From: Matt Herrick [mherrick@broadbentinc.com]
Sent: Wednesday, October 22, 2008 9:55 AM
To: Khatri, Paresh, Env. Health
Cc: rhmiller@broadbentinc.com; supplpv@bp.com
Subject: Soil and Ground-Water Investigation (Station 498 - Case #RO0002873)
Attachments: Google Maps Street View 498.jpg; Photo0026.jpg; Drawing 1.pdf

This email serves as a response to our recent conversations regarding proposed soil and ground-water investigation work activities at the subject site. The September 2, 2008 *Soil and Ground-Water Investigation Work Plan* was completed. Per a request from the ACEH, the October 8, 2008 *Addendum Soil and Ground-Water Investigation Work Plan* was completed and included that addition of a fourth monitor well MW-4. Proposed well locations included in the addendum work plan are provided in the attached Drawing 1.

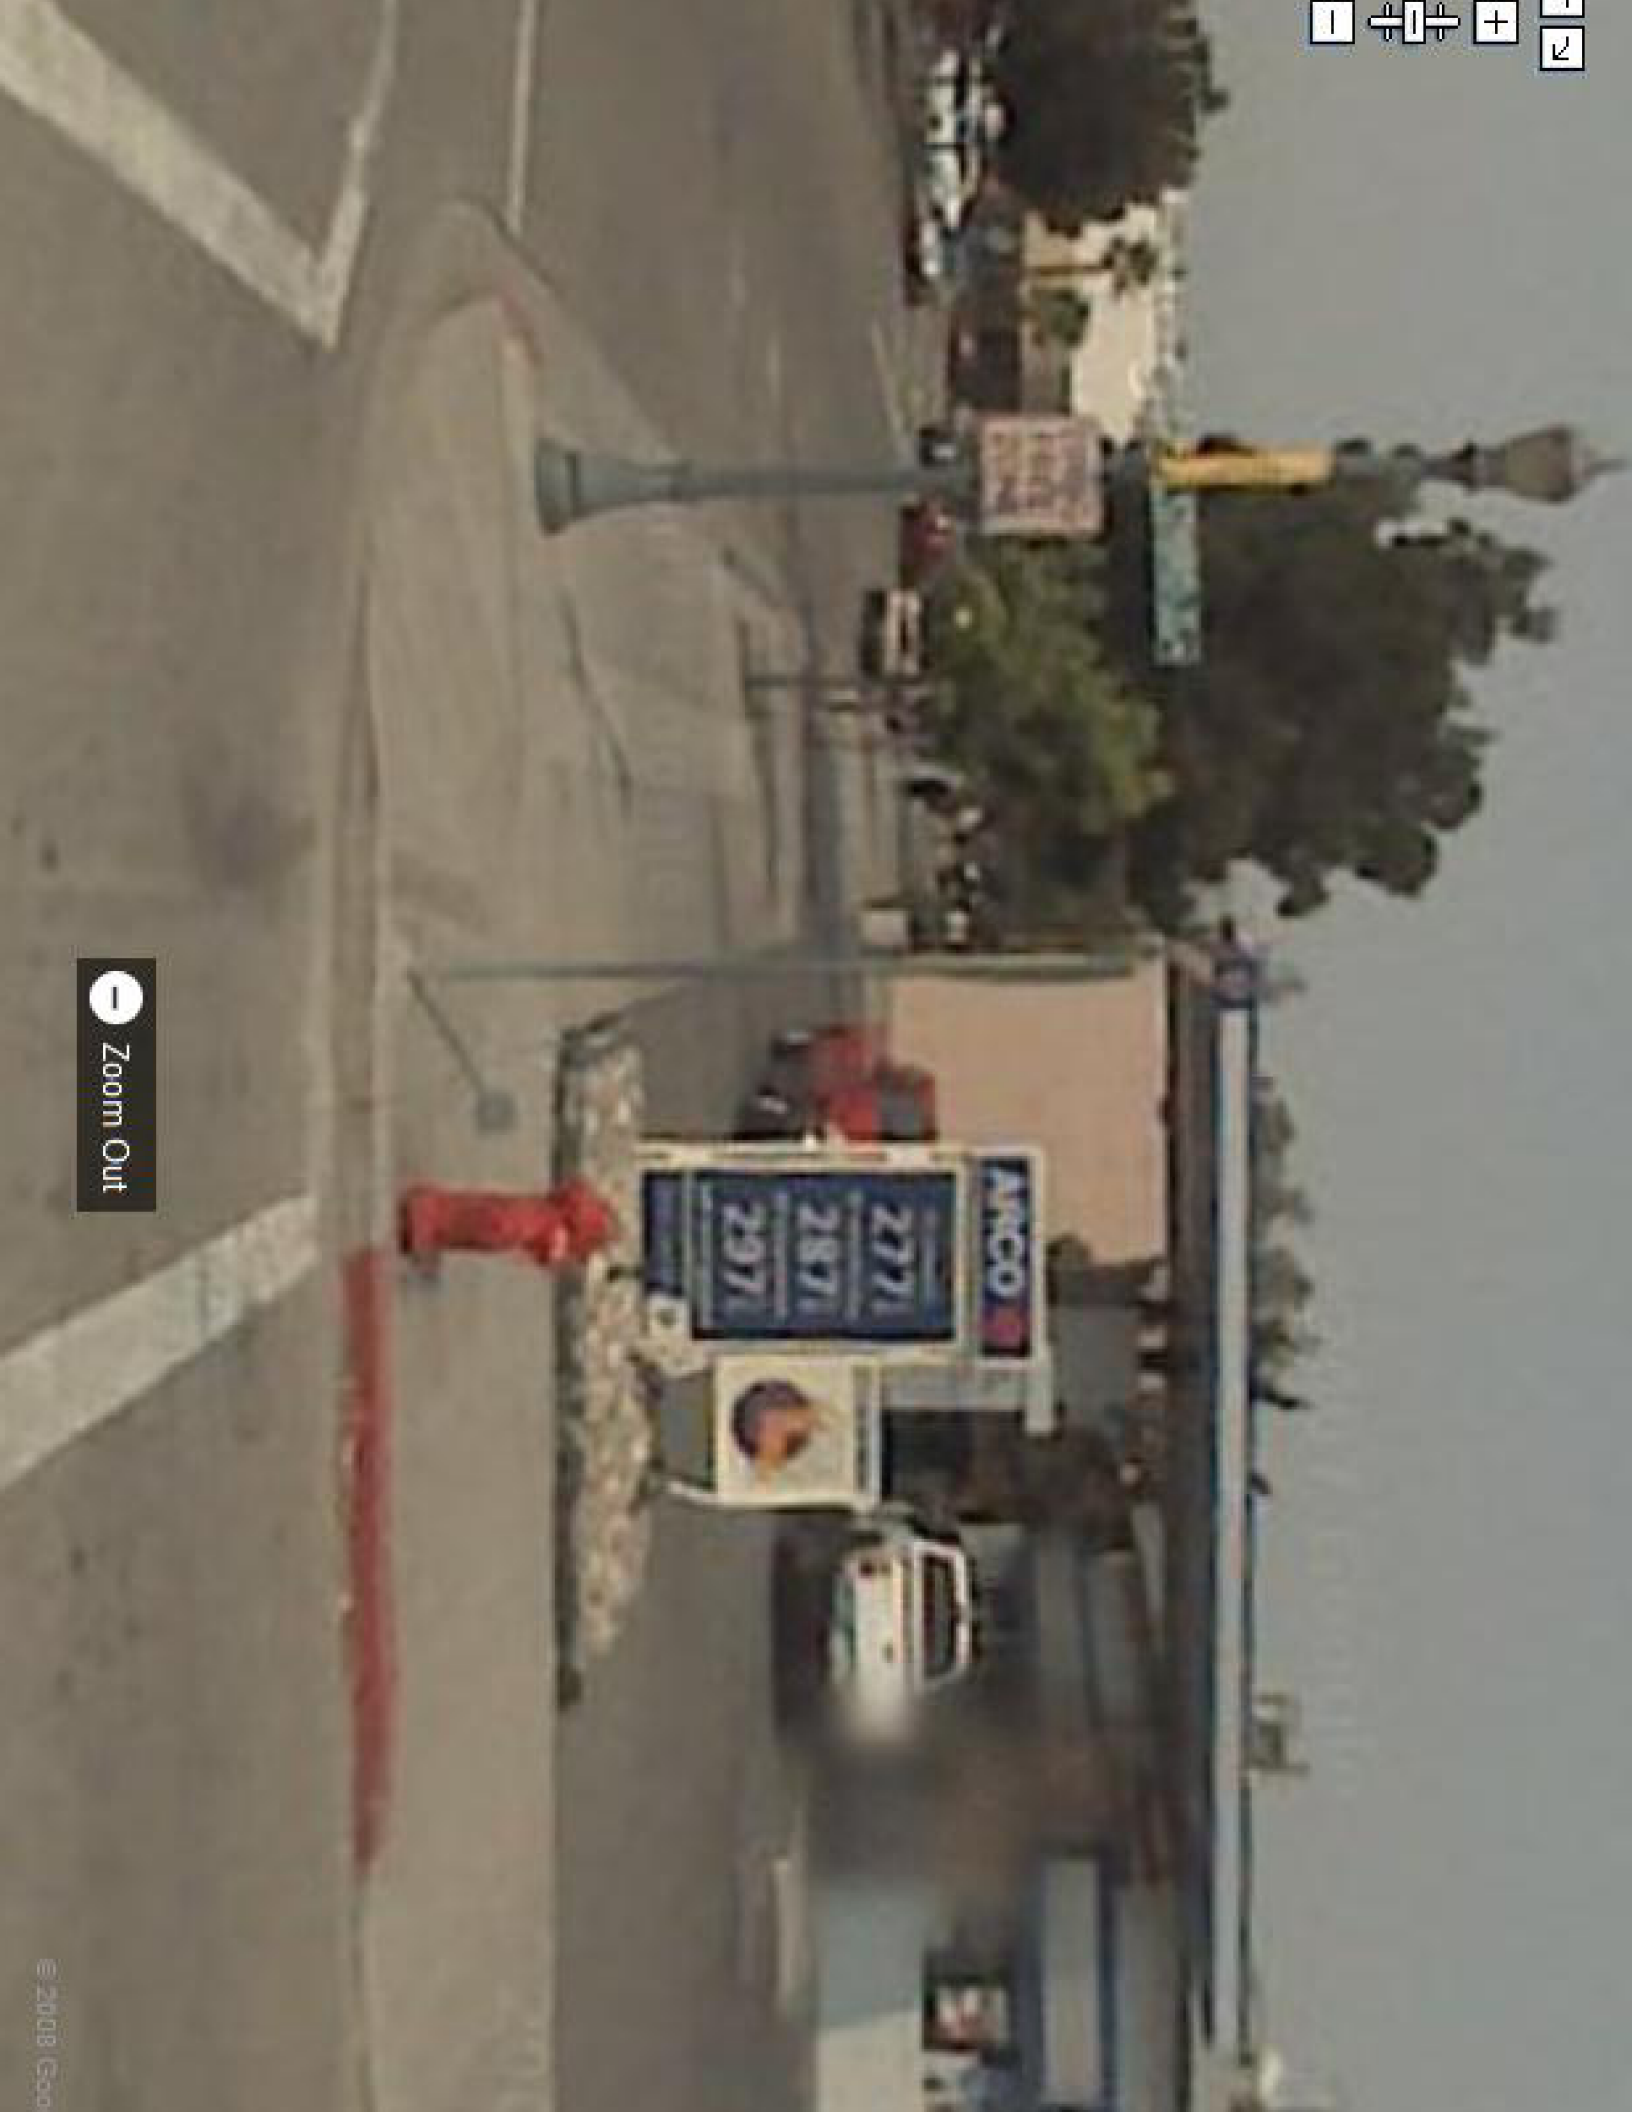
Upon review of the addendum work plan, you contacted me to discuss the possibility of moving well MW-4 in a northwesterly direction from its current location. You stated that the goal was to move well MW-4 closer to historic fuel dispenser location DP-3. I have attached two photos that depict this area of the property. The second photo (Photo0026) was taken by me about 2 weeks ago. The photos show the presence of two trees to the southwest of the canopy. We have also confirmed that the property line depicted in the attached Drawing 1 is correct. As the site map and photos indicate, the fuel dispenser canopy extends to the property line. If we were to move proposed well location MW-4 to the northwest and closer to historic sample location DP-3, the well location would be underneath the canopy and within a fueling area on the property.

We have significant concerns regarding installing what could end of becoming a long term monitoring point within a fueling area on the property. It is therefore proposed that well location MW-4 remain at the location depicted in attached Drawing 1. If it is determined in the future that confirmation soil samples are needed in the vicinity of location DP-3, a boring could potentially be installed underneath the dispenser canopy.
